## IMPORTANT SAFETY RECALL NOTICE

Re: Defect Notice by Manac Inc. ("Manac")  
Certain Manac Flatbed and Dropdeck Models – Lashing Chains related Defect

# RECALL REMEDY AND INSTALLATION PROCEDURE FOR MANAC REPAIR CENTERS

## Tie down chain aluminum shim

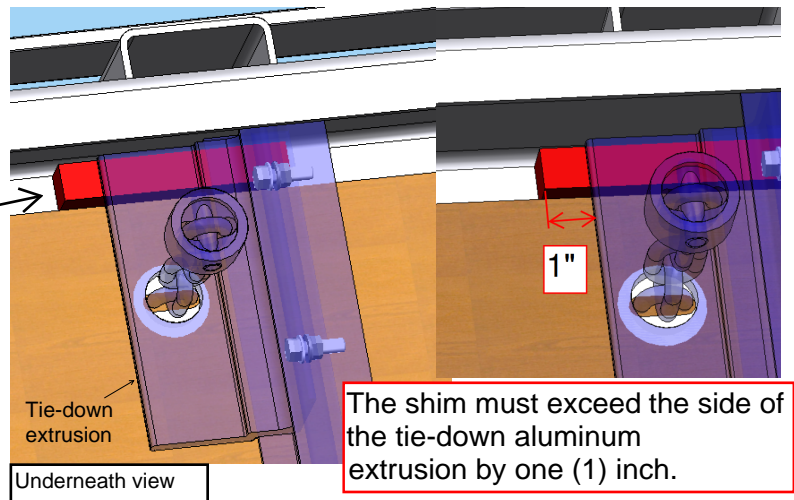
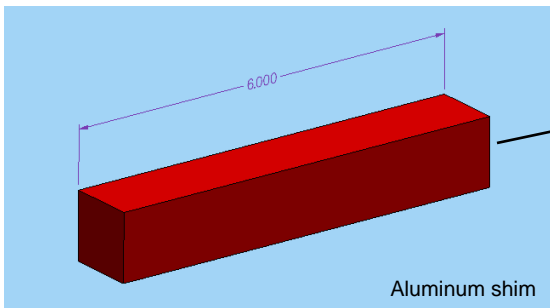
1- Insert the aluminum shim underneath the floor of the trailer, between the tie-down extrusion and the siderail.

Underneath views of weld

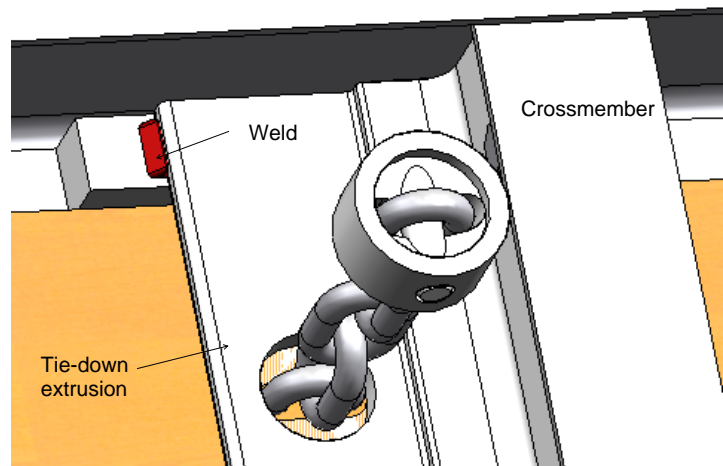
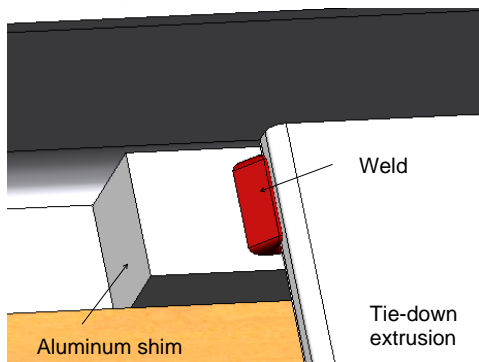
2- Weld the shim on the aluminum extrusion with a TIG or a MIG welder. The weld size must be 1/4" and must have a minimum of 3/4" long.
